A G E N D A

Architectural Review Board

July 27, 2021 – 5:30 p.m.

9A

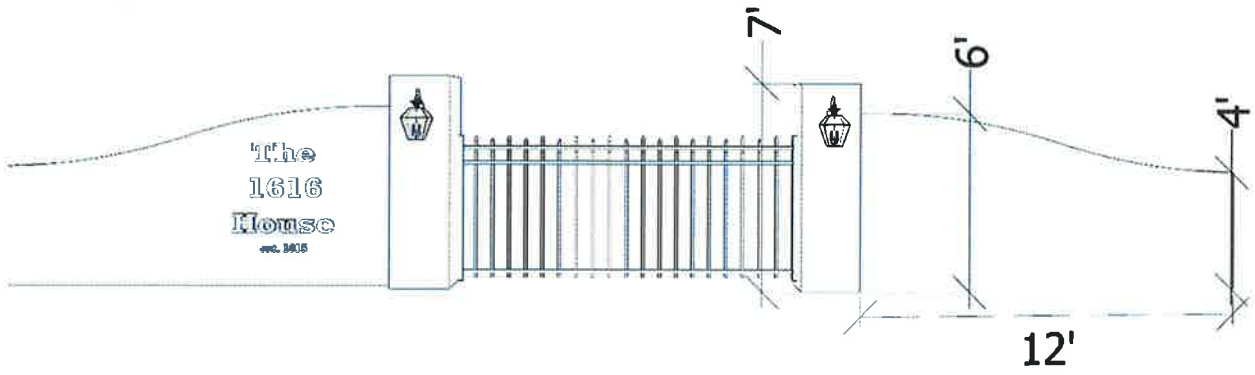
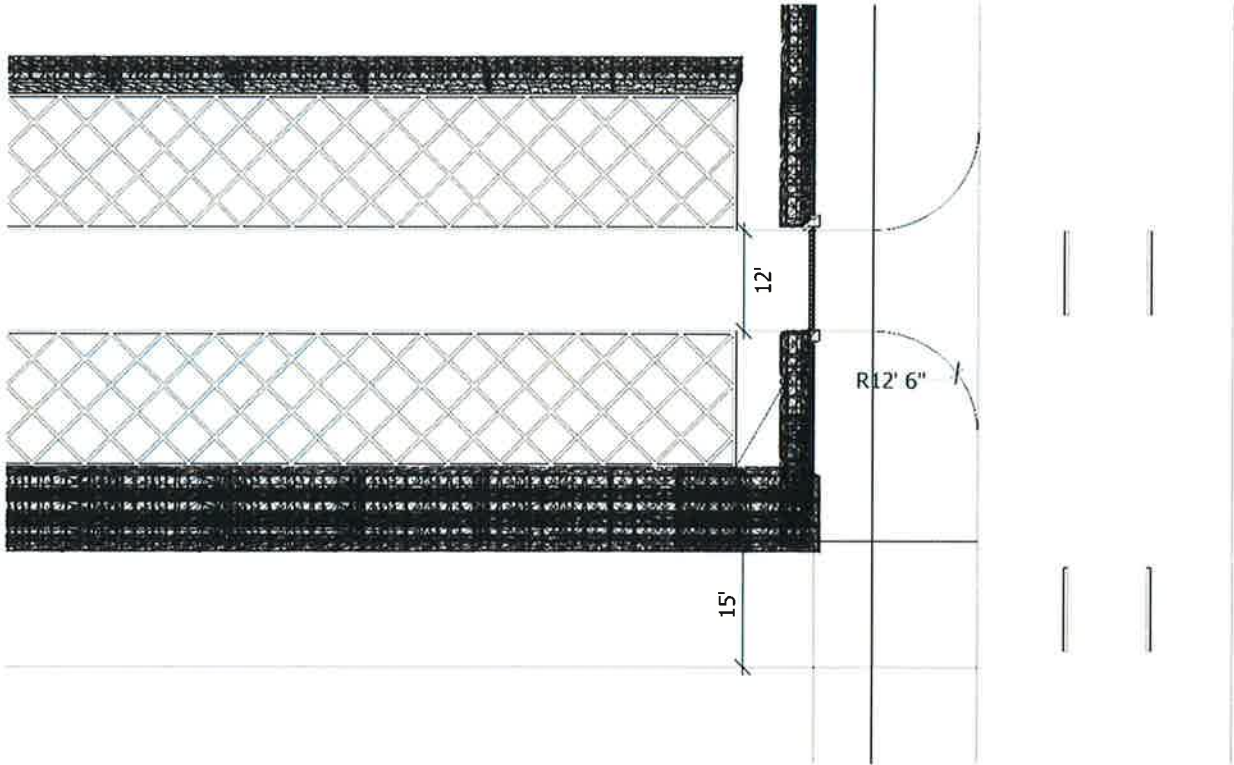
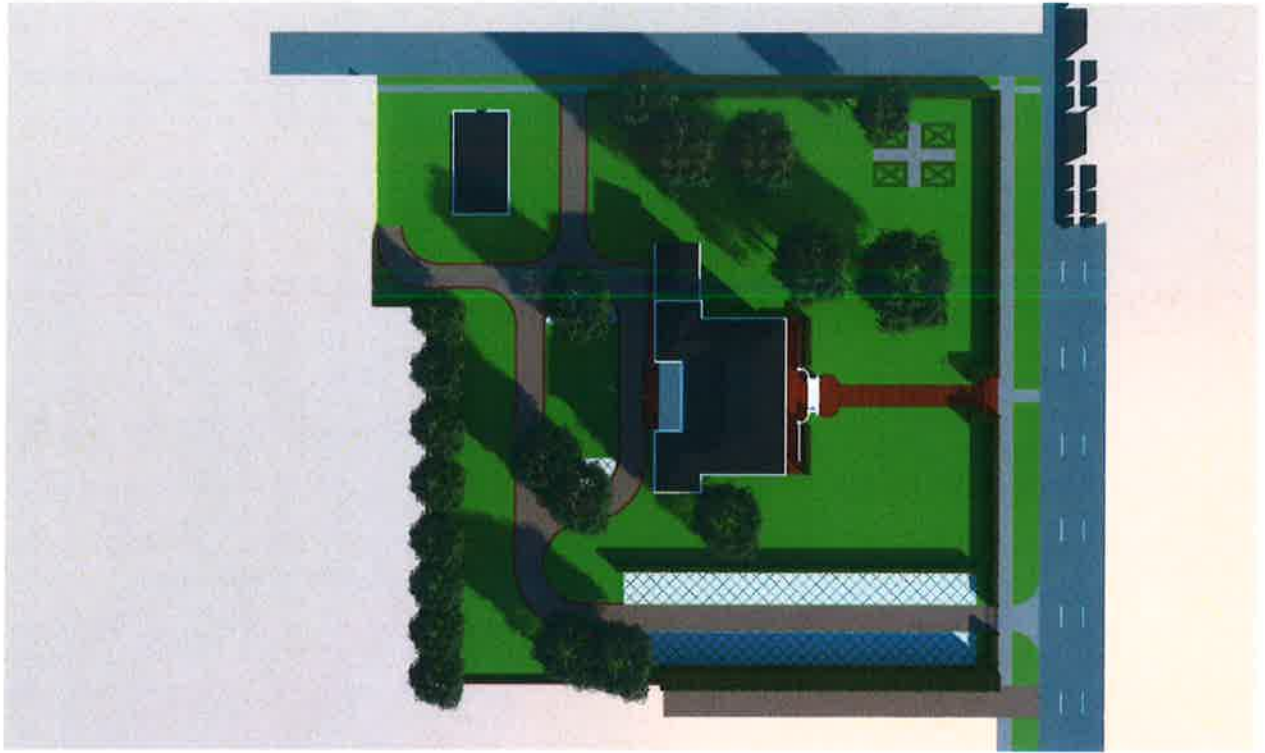
- Because the property is zoned B-1-b-q, no variance would be required for the gate or wall sections that are proposed.
- There have been concerns expressed that the plan is not being executed as previously approved—namely the use of turf strips applied to solid concrete where grass planting strips between 4'x4' slabs on diagonal were proposed. The concrete parking area was reduced in length, and visually meets what was approved by the Board. It was determined, in consultation with the Board chair, that because the parking area is a new, non-historic feature, that the project could move forward so that we could determine how visible this feature is with all the proposed screening in place. It has not been our practice to stop projects mid-stream unless there have been wild deviations in the plan, which we determined not to be the case. We have also been made aware that someone on S. Hull has an astroturf putting green in their backyard.
